ANNE ARUNDEL COUNTY

April 13, 2021

RE: Perc #T02048264
Tax Account #300001214820
Site: 5 GENE AVE
PASADENA

# DEPARTMENT OF HEALTH PERC DATA FORM

### SOIL TEST/SITE EVALUATION

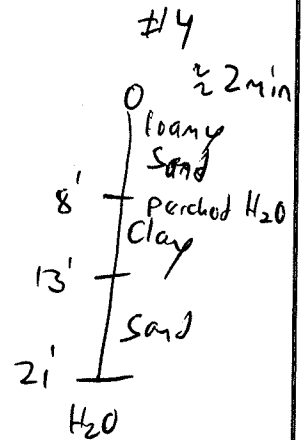
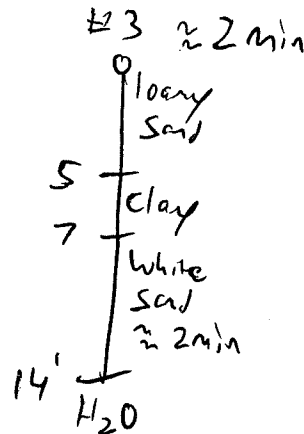
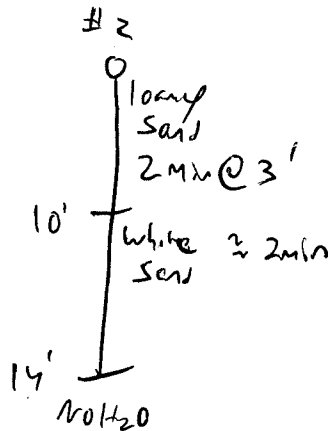
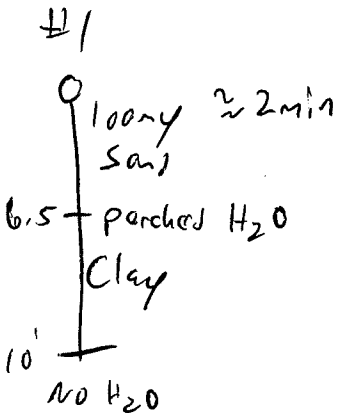
1  
25 } 1.5' @ 2min  
 9(34)(.71) = 217'  
 3-73' trenches  
 3'w 2.5'd  
 pipe @ 1'  
 10' separation

2  
10 } 8' @ 2min  
 9(34)(.25) = 77'  
 1-77' trench  
 3'w 10'd  
 pipe @ 2'  
 18' separation

2  
5 } 3 } 6' @ 2min  
 5 } 3 }  
 10 }  
 9(34)(.31) = 95'  
 1-95' trench  
 3'w 10'd  
 pipe @ 2'  
 15' separation

1  
4 } 3' @ 2min  
 9(34)(.5) = 153'  
 3-51' trenches  
 3'w 4'd  
 pipe @ 1'  
 10' separation
